Model: DADF-J1

Ref. No. : FF-T01-X-000047-01

Location: Pick-up Tray PCB Assembly

Subject: Preventing Damage to the Pre-Last Original Sensor

<Factory Measure>

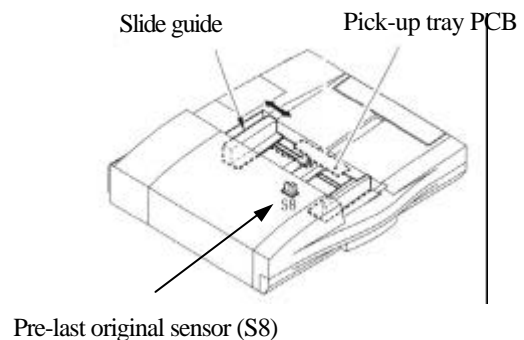
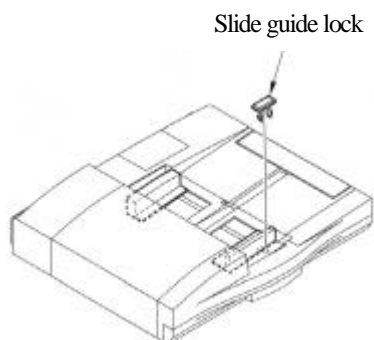
Reason: If the slide guide lock of the ADF has been removed, the contact plate (5V) operating in conjunction with the slide guide can cause a short circuit between the pattern of sensor LED (mounted on the pickup tray PCB) and the pattern of photo elements, ultimately damaging the pre-last original sensor (S8; FG6-7735-000).

If the slide guide lock has been removed, the contact plate operating in conjunction with the slide guide can cause a short circuit between the pattern of sensor LED (mounted on the pickup tray PCB) and the pattern of photo elements.

The pattern of the pickup tray PCB is changed so that the contact plate will not cause it to short circuit even in the absence of the slide guide lock.
